# SUPERSTAR CARWASH

## MEADOWBROOK PKWY

Add Site Development Plan title

COVER SHEET

Drawn By: AJJ  
 Checked By: SEM  
 Date: 03/16/2023  
 Project No. 24-0409  
 Sheet Number  
**C5.1**

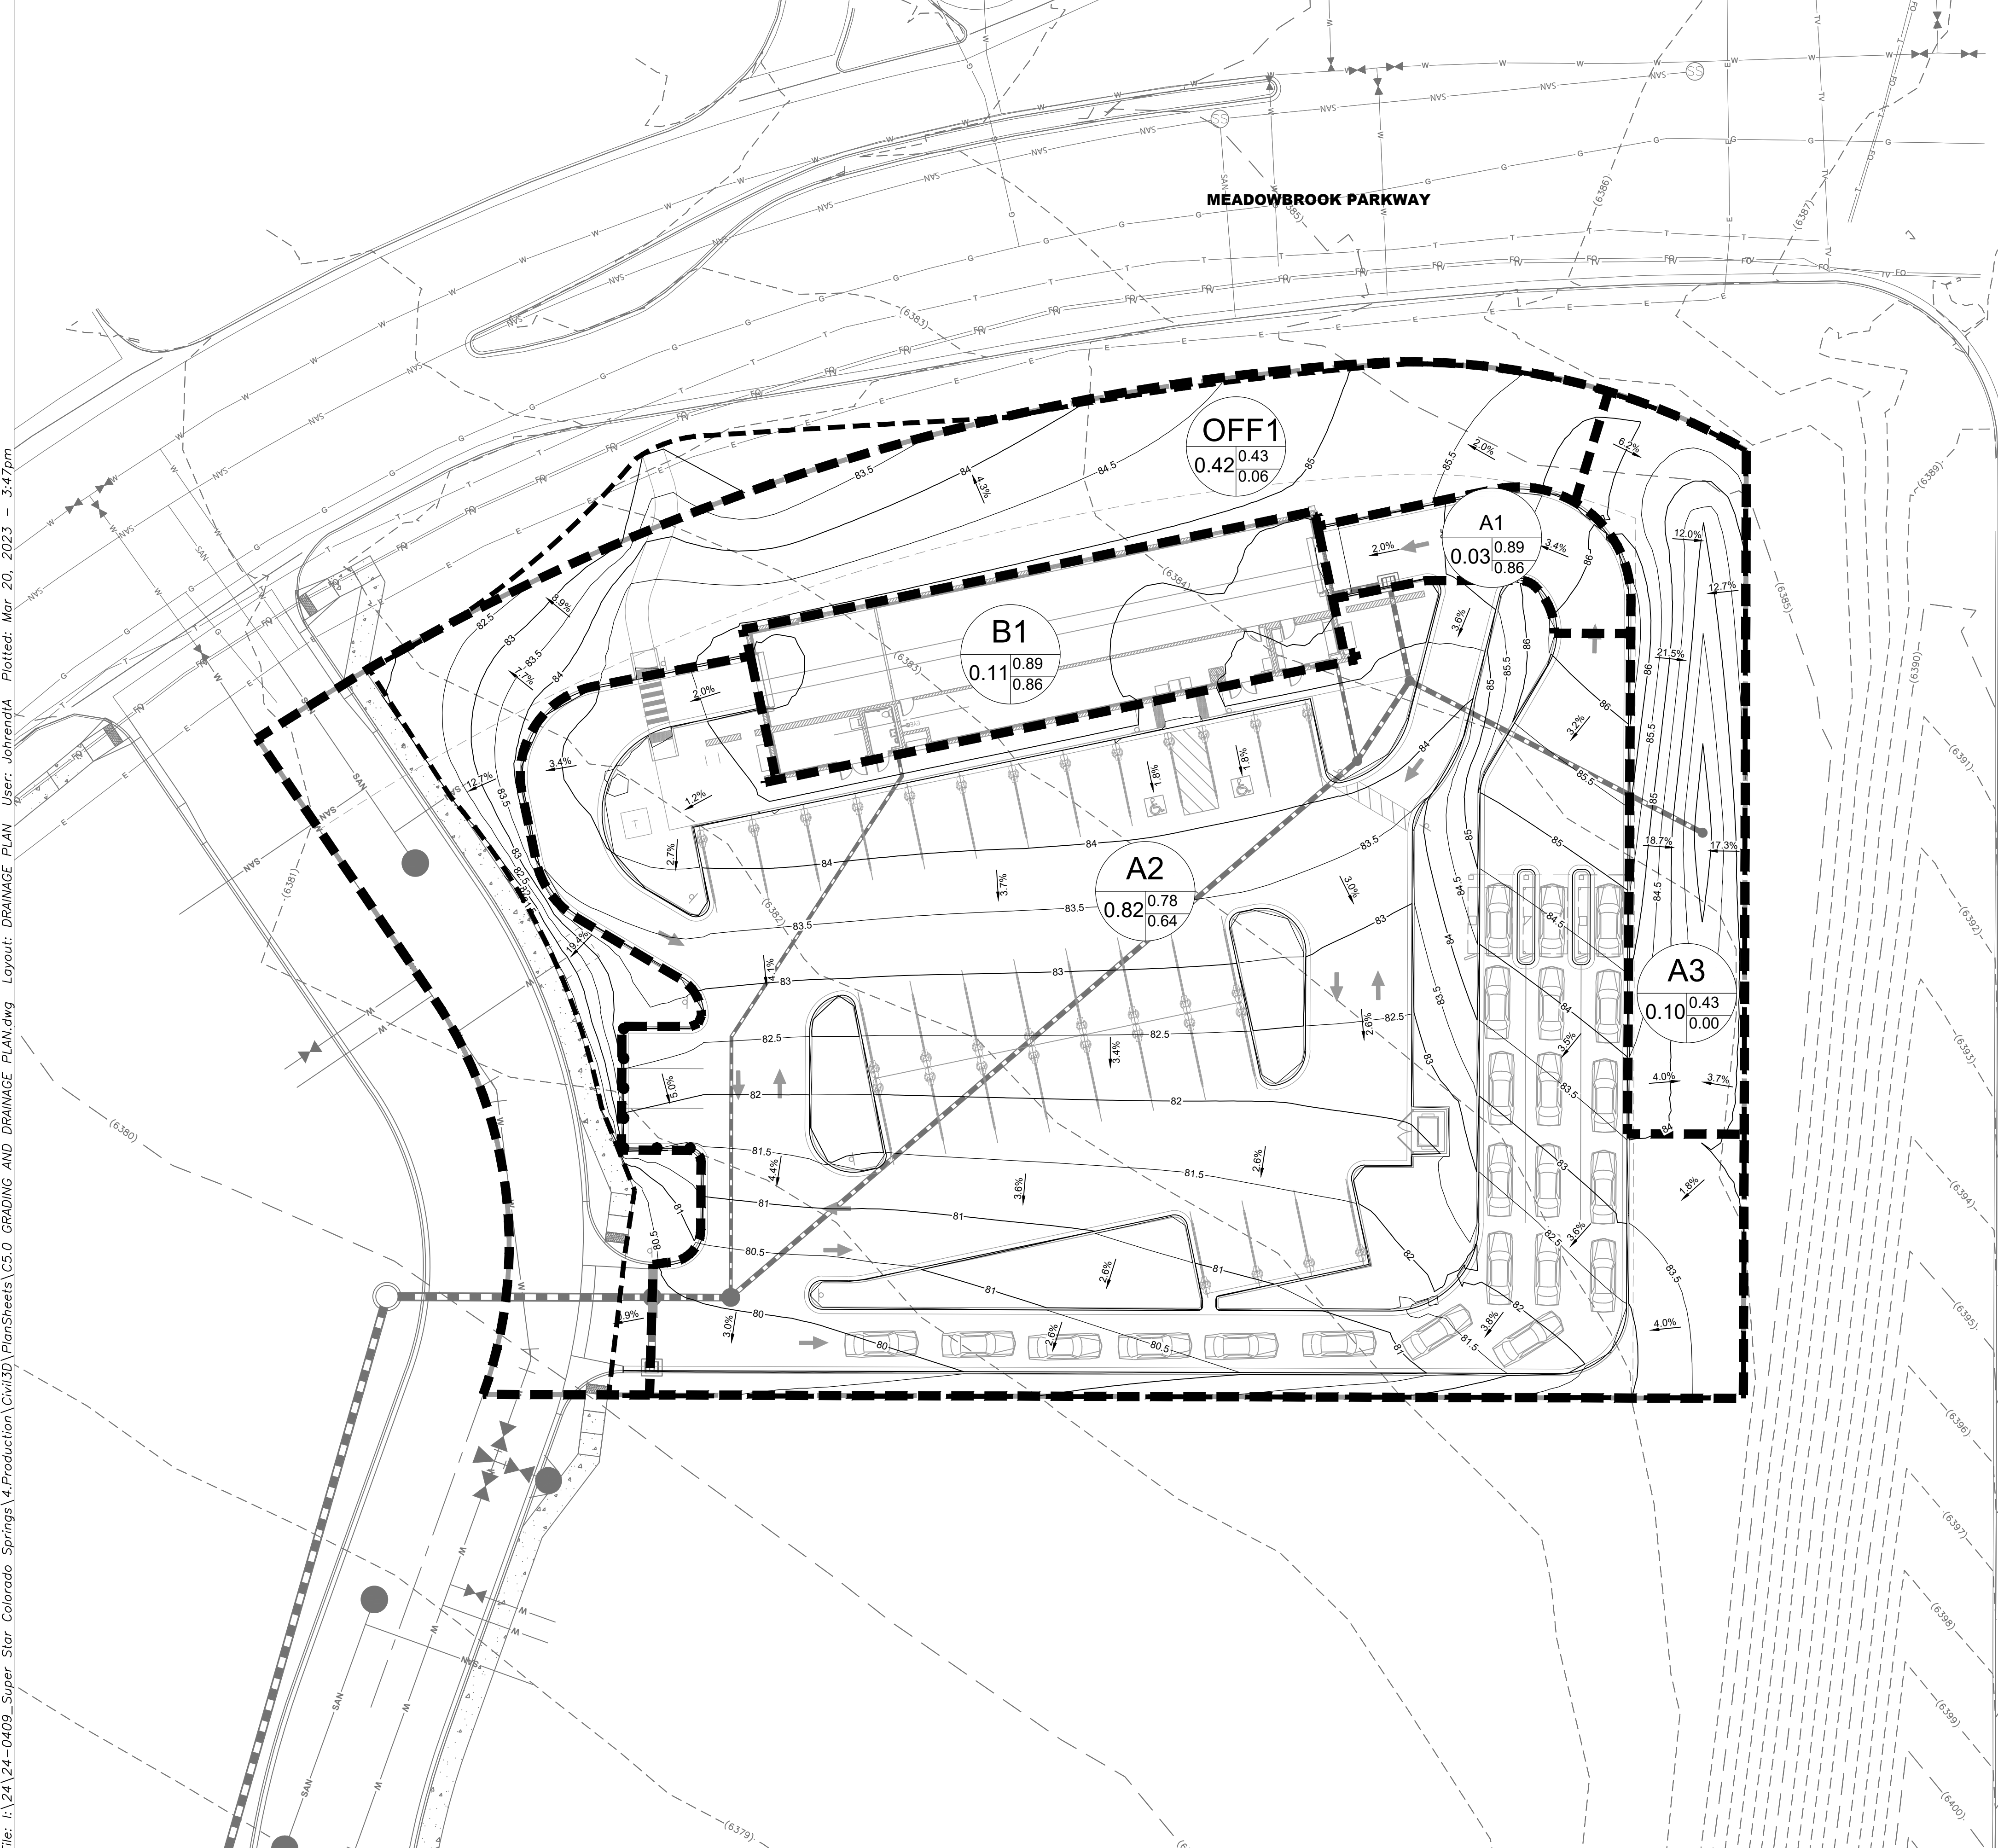
The drainage report does not clearly state this. Add text to the drainage report to clarify and demonstrate that the pond was designed to have capacity for the fully developed site.

**C7.0**

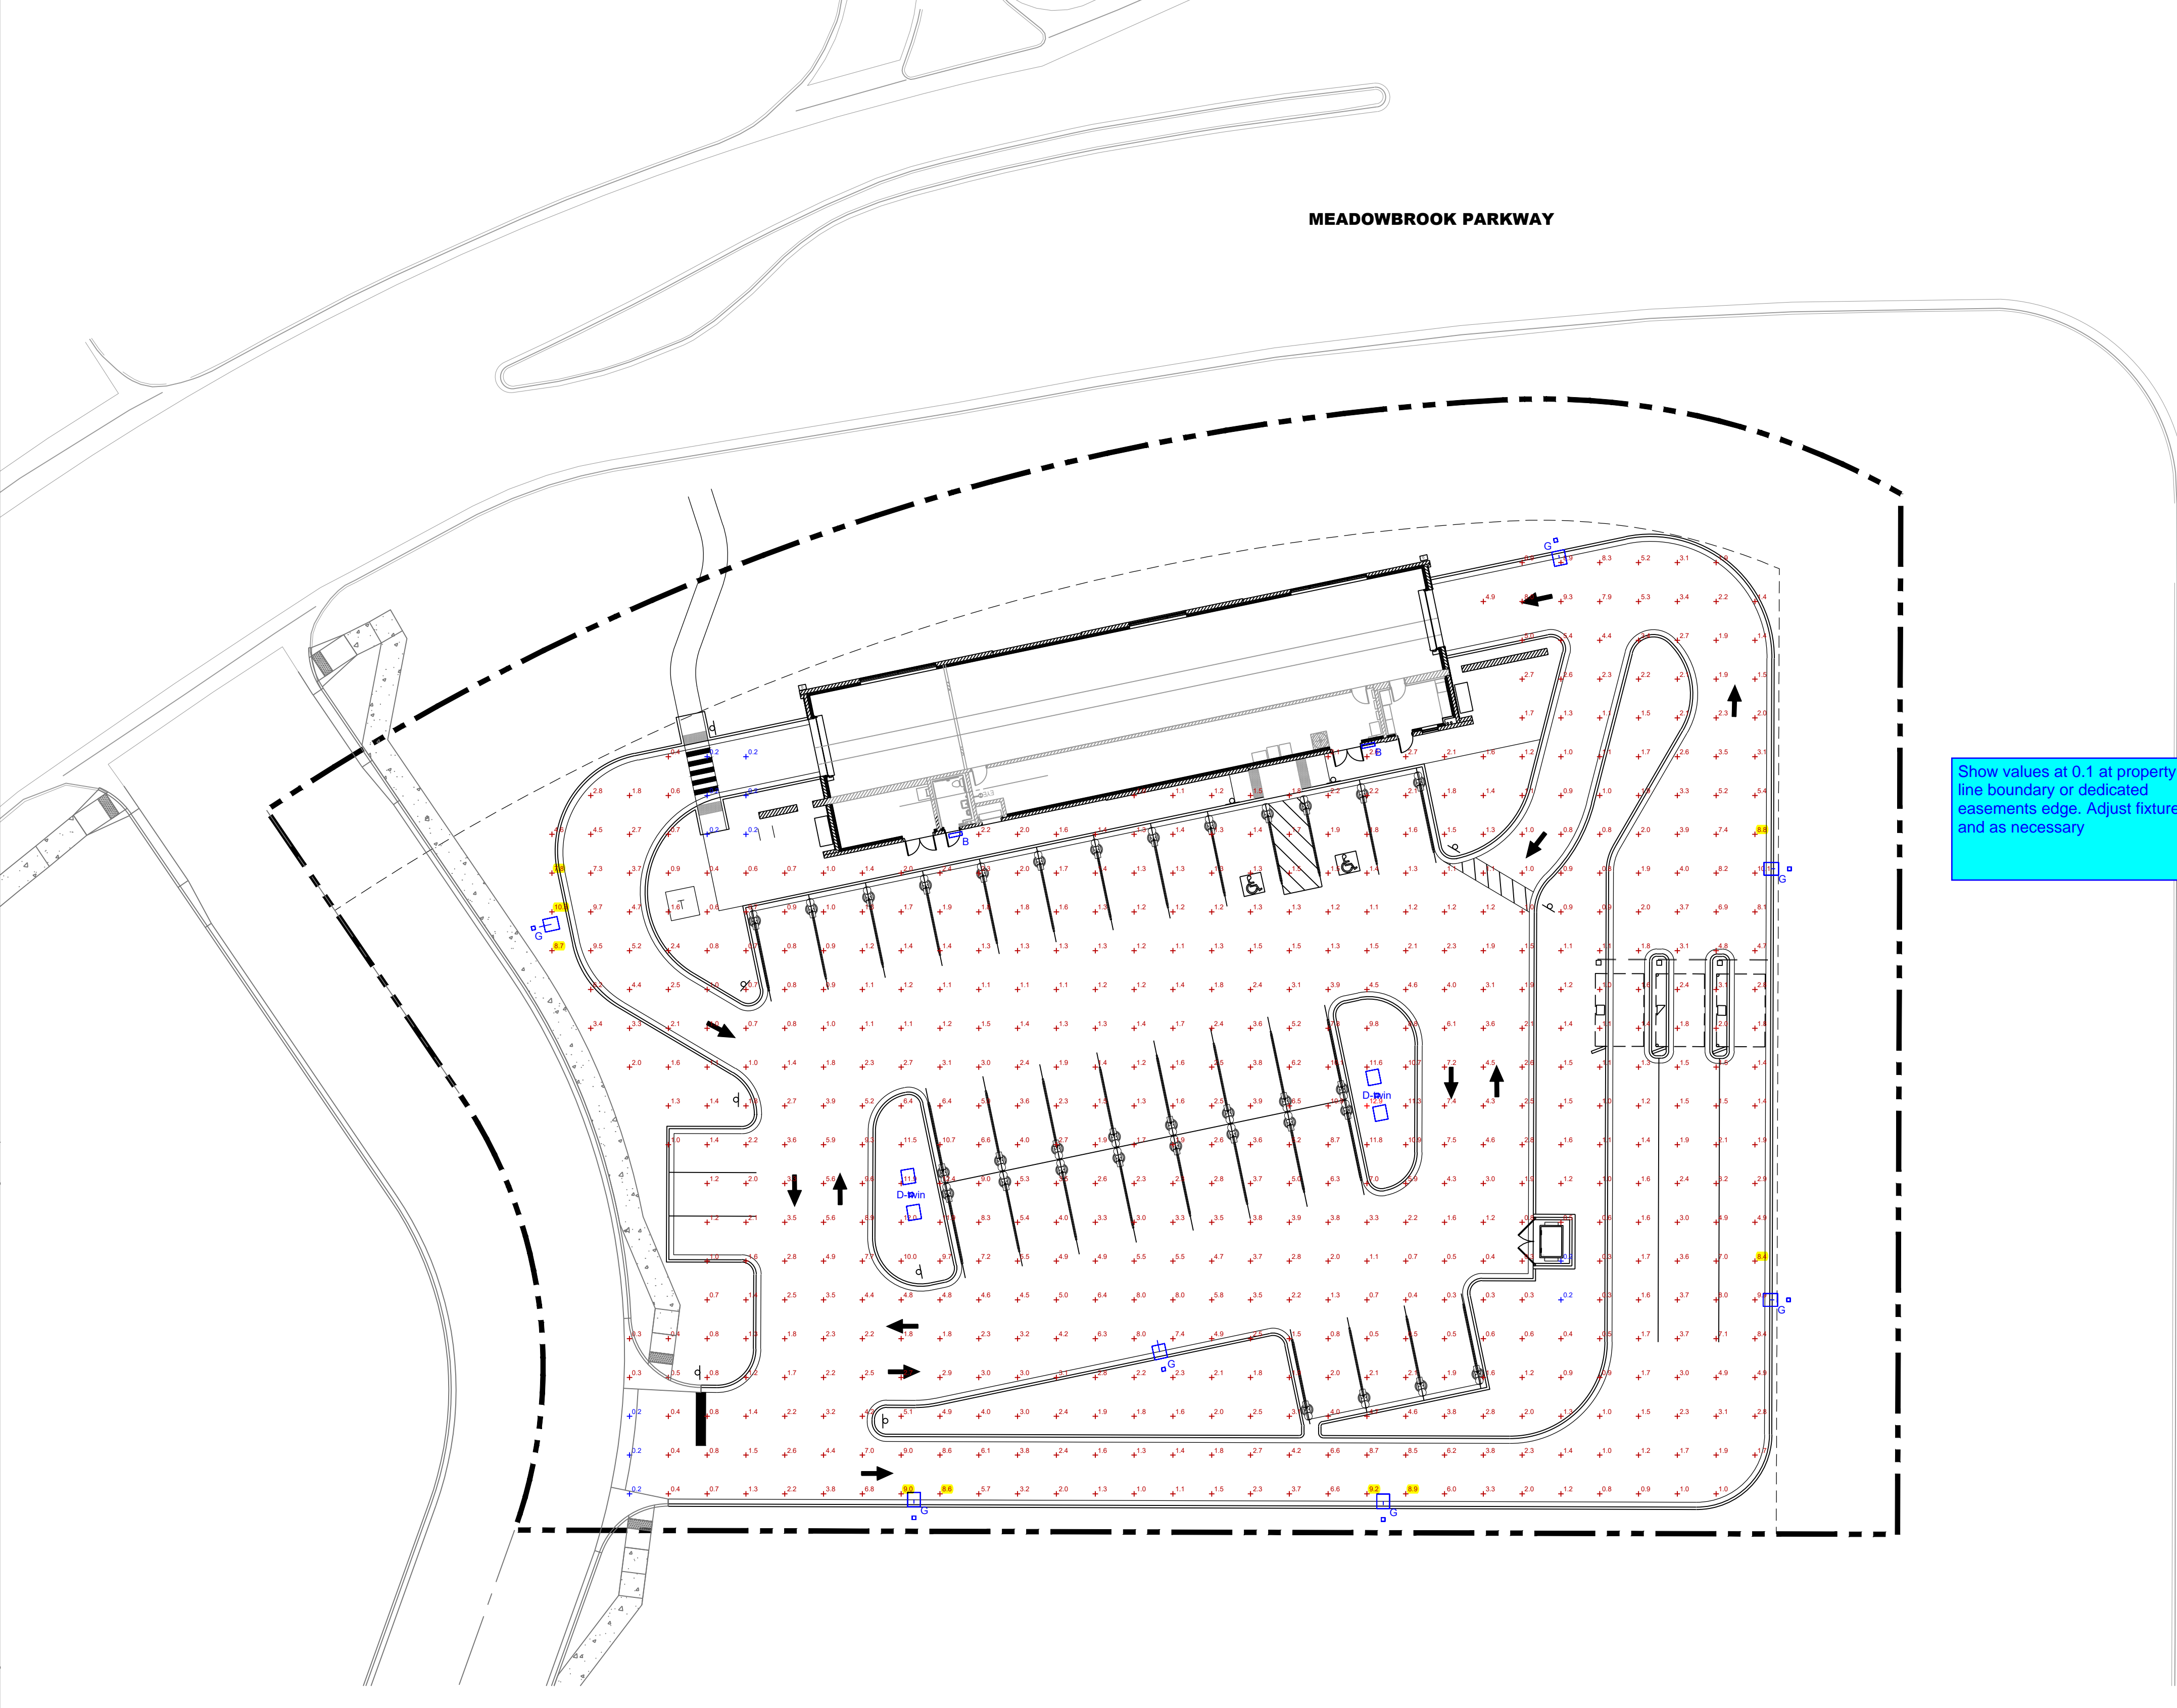
Show values at 0.1 at property line boundary or dedicated easements edge. Adjust fixtures and as necessary
